**Town of Kittery
Planning Board Meeting
February 13, 2020**

ITEM 1 – 76 Dennett Road – Sidewalk/Street/Landscape Design Discussion

Re: Landscape Design Review
Response to Ironwood Design Group Review Comments
Proposed Mixed-Use Development at 76 Dennett Road
Tax Maps Lots 6-15B, 6-16A, 13-4, Kittery, Maine

**RE: Town of Kittery, Planning Board Services
Mixed-Use Development Proposal – 76 Dennett Road Lots 6-15B, 6-16A, 13-4
Final Review Comments - January 23, 2020 Submittal
CMA #591.125**

REAR LANDSCAPING PLAN
C19
PROJECT NO. 569200
SHEET 19 OF 27

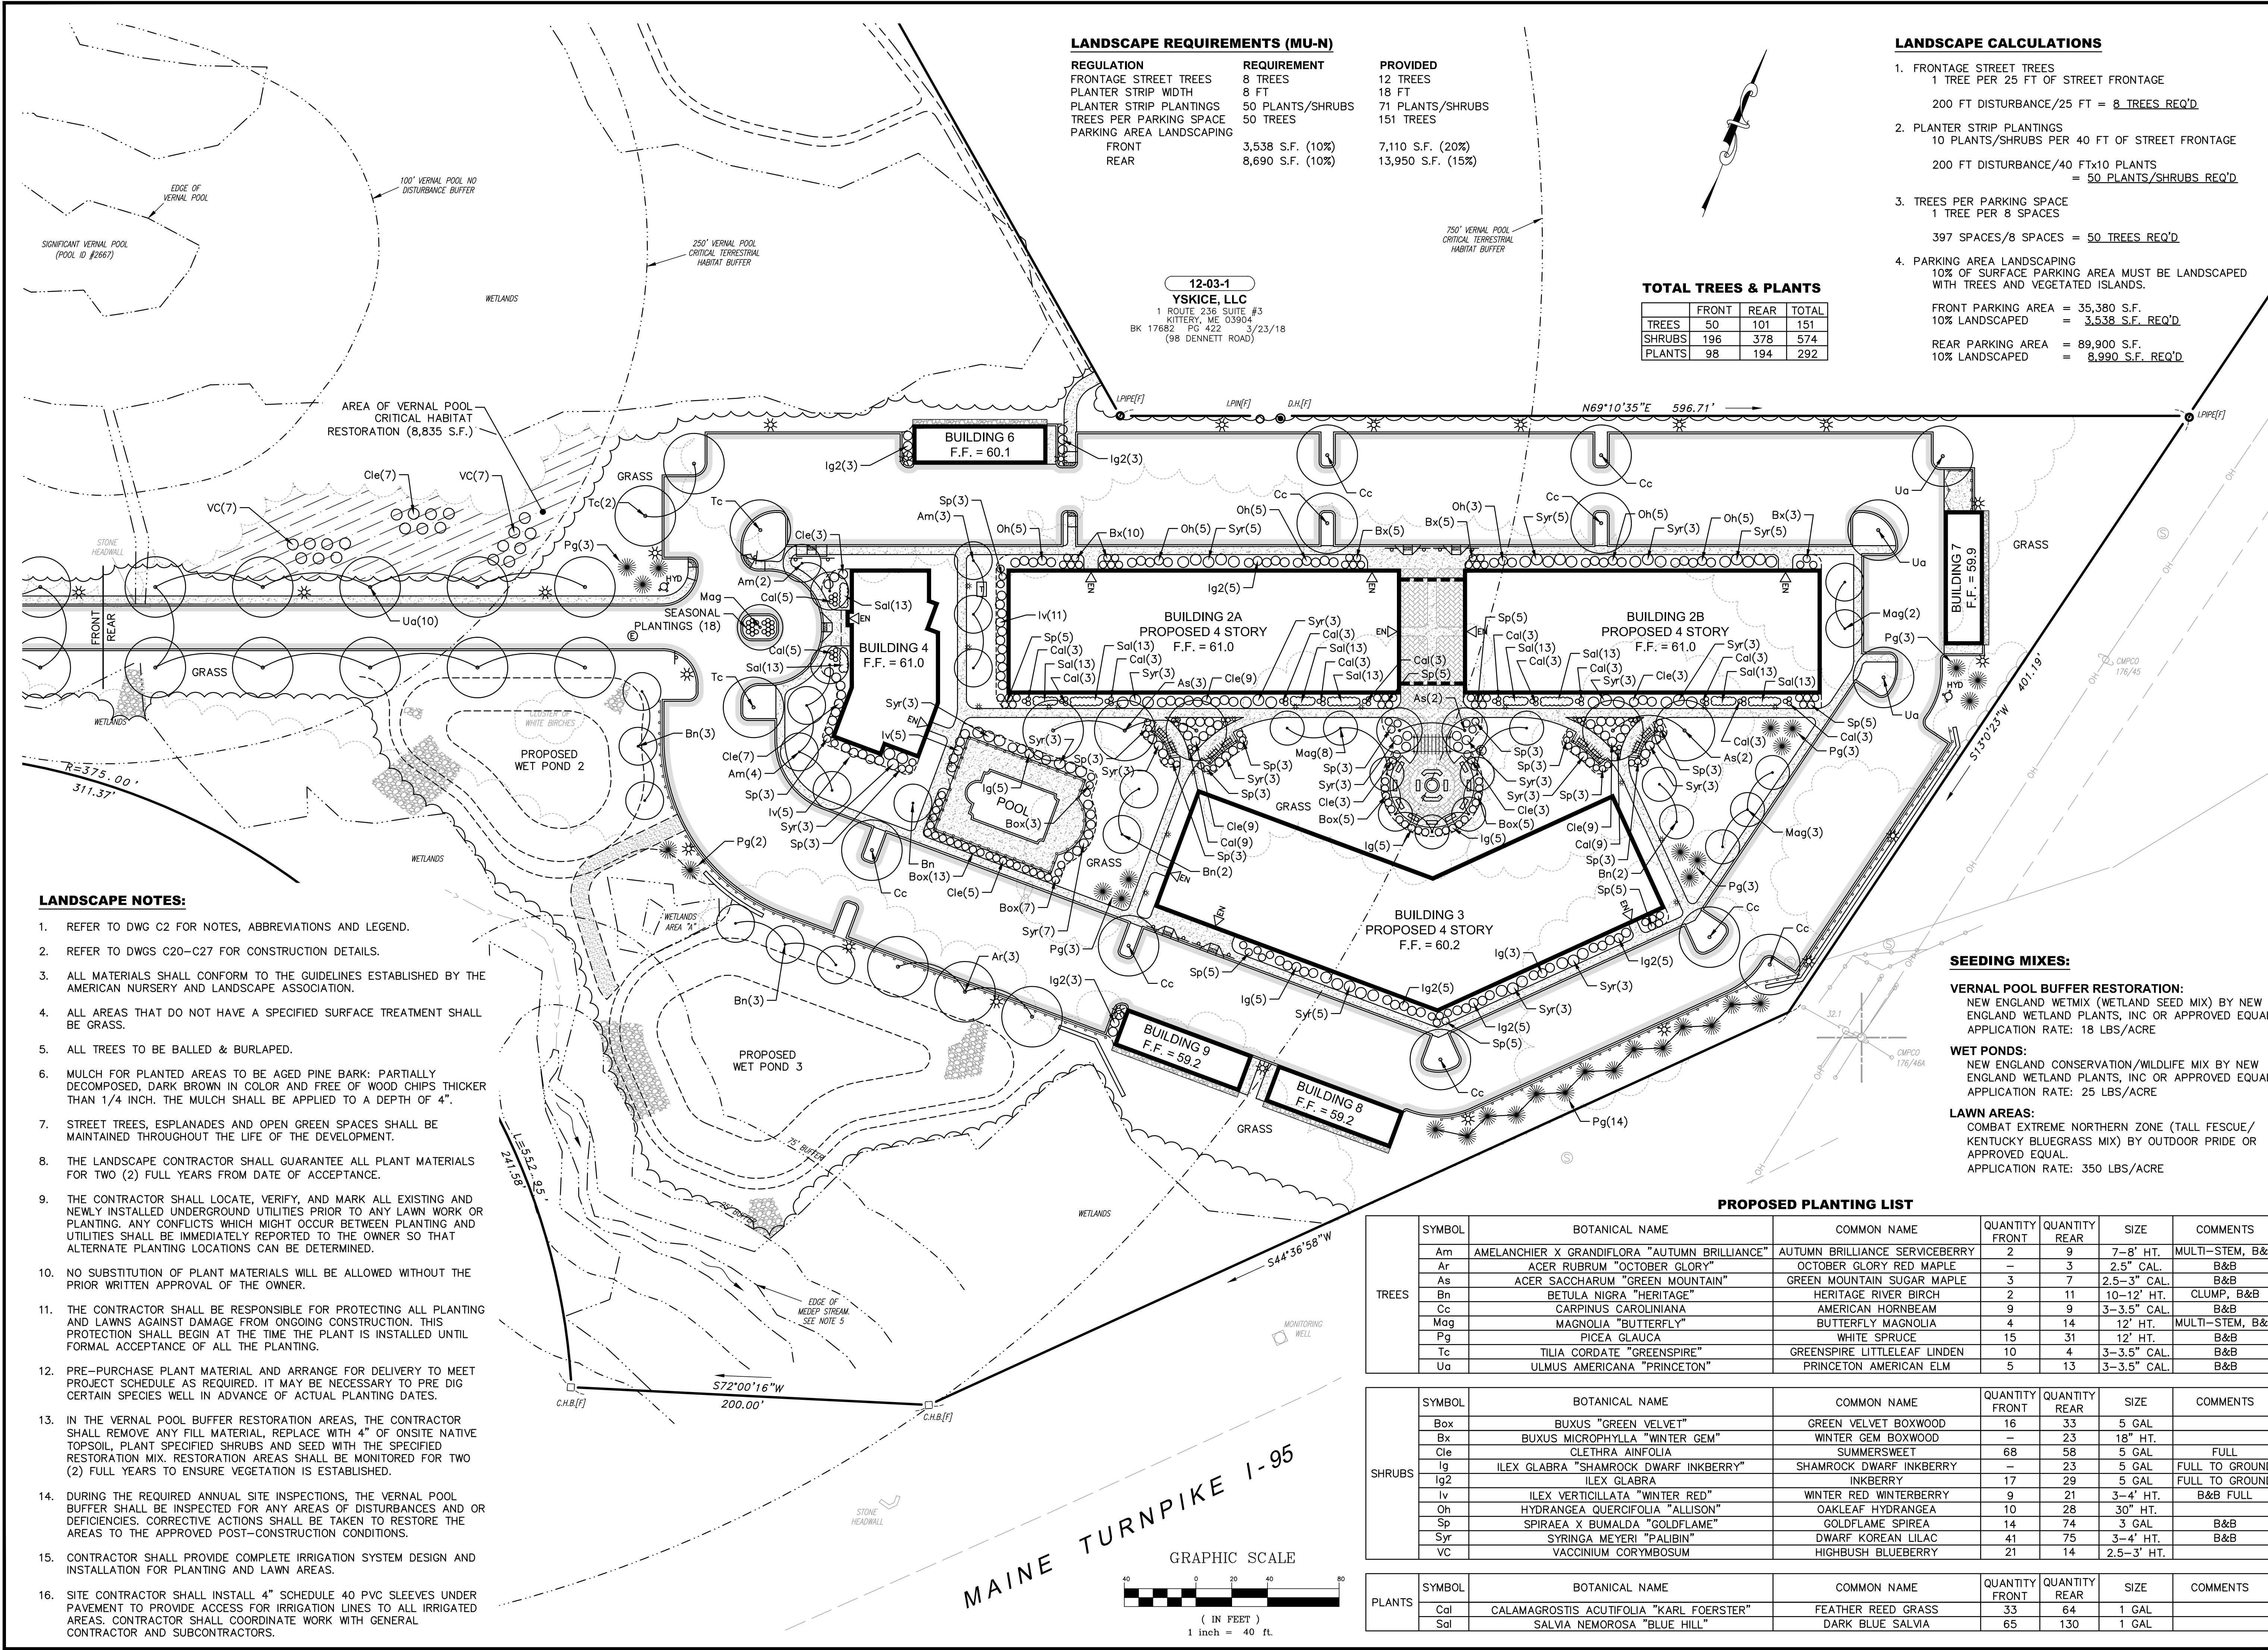
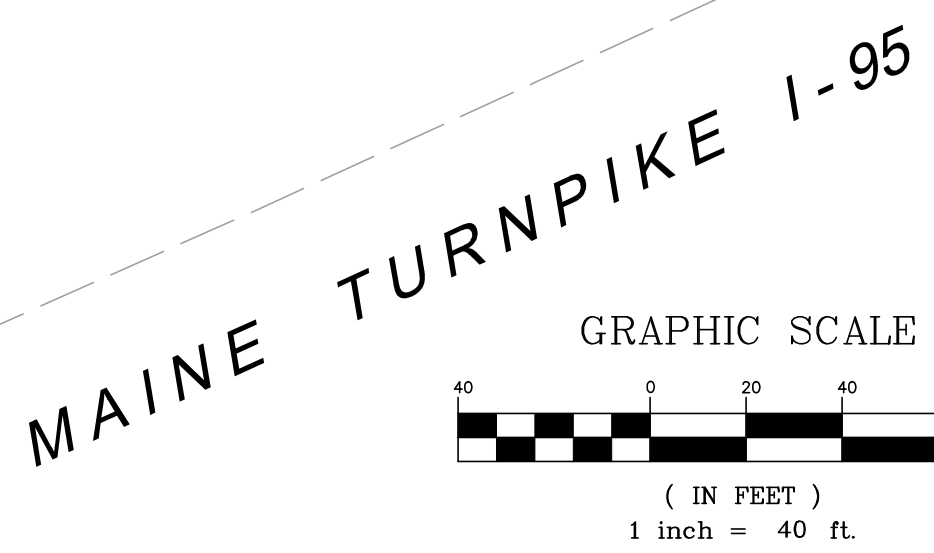
1. Clarify the soil and planting treatment for the area of vernal pool buffer restoration. Clumps of shrubs are shown but the planting for the large areas between these shrubs is unclear. If the area is to be seeded, seed mix should be specified.

2. Specify seed mix/planting plan for the proposed wet ponds.

3. Specify grass seed mix and provide grass planting detail.

Note #13 on sheets C18 and C19 was revised to read as follows: "In the vernal pool buffer restoration areas, the contractor shall remove any fill material, replace with 4" of onsite native topsoil, plant specified shrubs and seed with the specified restoration mix. Restoration areas shall be monitored for two (2) full years to ensure vegetation is established."

A vernal pool buffer restoration seed mix was added to sheets C18 and C19.

A wet pond seed mix was added to sheets C18 and C19.

A grass seed mix was added to sheets C18 and C19

A life maintenance note (note #7) for street trees was added to sheets C18 and C19

The plans were revised to specify irrigation for planting and lawn areas as specified in notes #15 and #16 on sheets C18 and C19.

6 DOUBLE DUMPSTER PAD ENCLOSURE DETAIL
SCALE: NONE

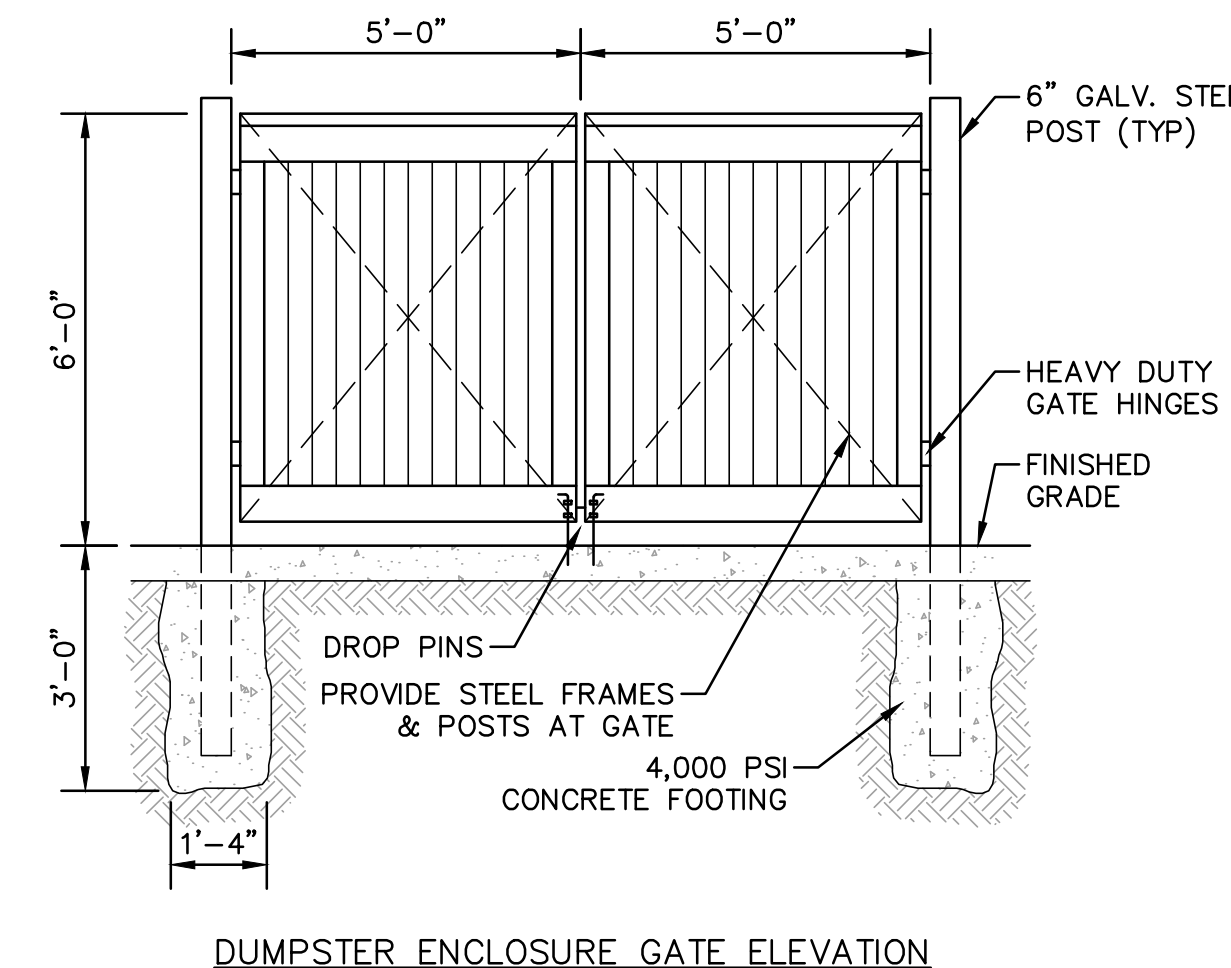
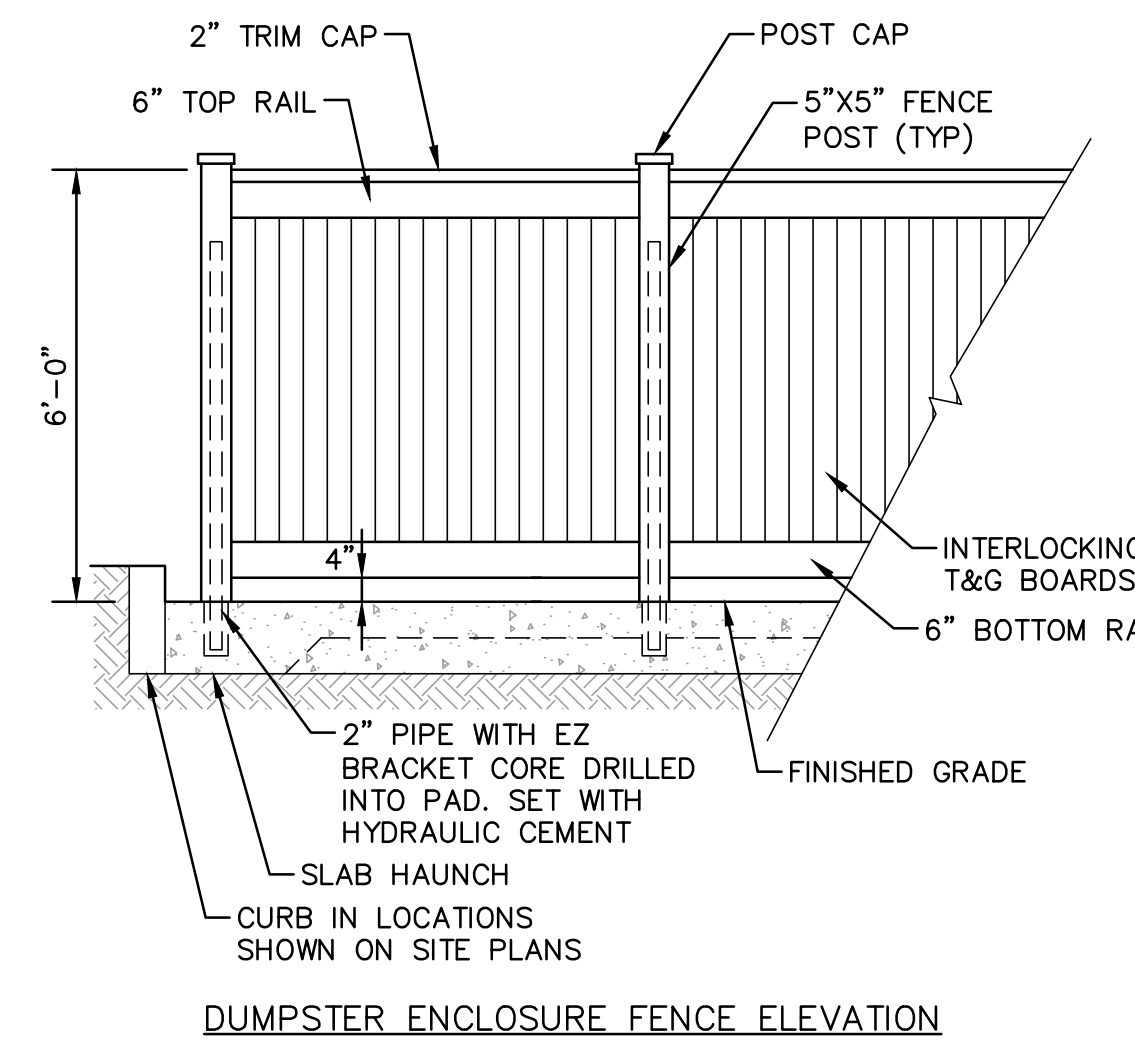
21. *The following comments refer to Detail 10/C24 Dumpster Vinyl Fence:*

- b. The fence detail lacks information to determine if it will be able to withstand the demands that a typical dumpster enclosure is subjected to. Provide the following information:*
 - i. Information related to internal rain reinforcement. Given the 9' span steel reinforcement may be warranted.*
 - ii. Provide clarification on the style of panel. Typically a picket (specified) is spaced out vs. inter-locking T&G which would be solid.*
 - iii. Provide post information, is the post pressure treated with a vinyl sleeve, solid vinyl, or hollow.*
 - iv. Provide additional hardware information for the following: hinges, latches, drop pin, fasteners, specifically size, material, finishes, and strength rating.*

The dumpster enclosure detail was revised to include all the above comments. For reference, the detail has been relocated to #6 on sheet C26 due to additional details added to the plan set.

3 CONCRETE PAVER SETTING DETAIL
SCALE: NONE

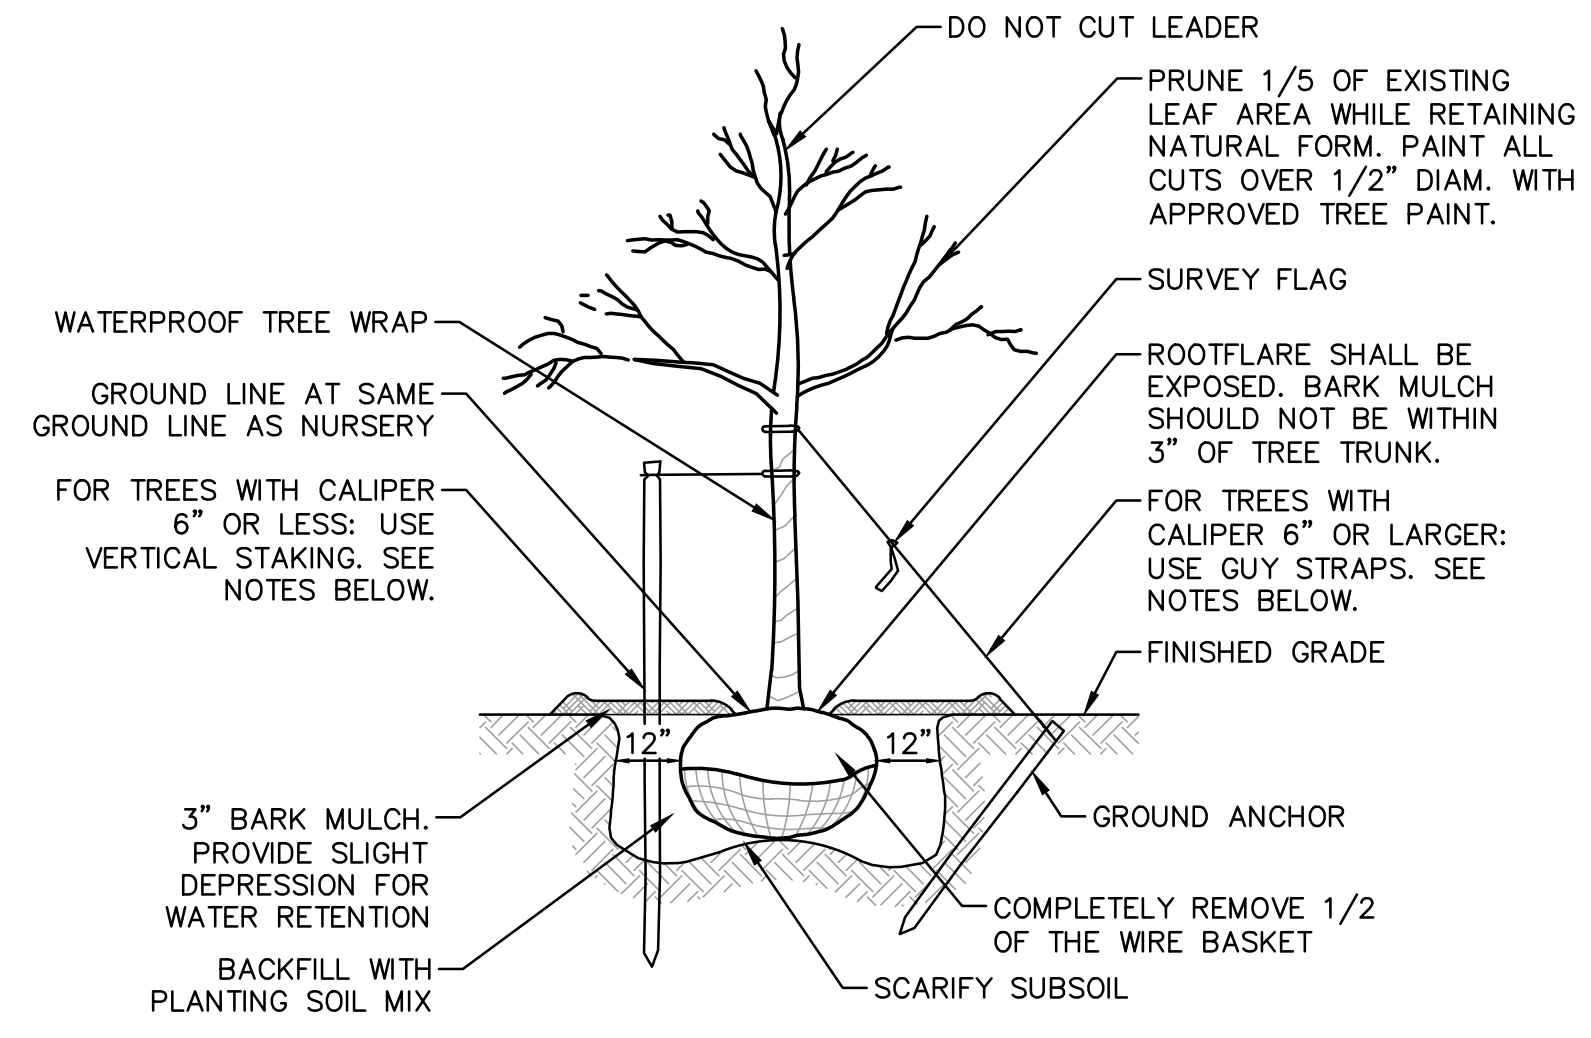
20. The following comments refer to Detail 6/C25 Brick Pavement Detail:

- a. The detail provided lacks some information and raised feasibility concerns. Provide the following information and/or questioned responses.*

- i. Is the paver being proposed clay or concrete?*
- ii. A bituminous base in the application would be more typical unless heavy weight loading is anticipated.*
- iii. Consider providing weep holes in the base especially given the sand swept joints.*
- iv. Consider a sand or drypac setting bed with polymeric sand joints.*
- v. Identify the means of edge restraint.*

The paver detail was revised for a pedestrian application as we do not anticipate vehicular loads on the proposed pavers. The detail has been relocated to #3 on sheet C27 due to additional details added to the plan set.
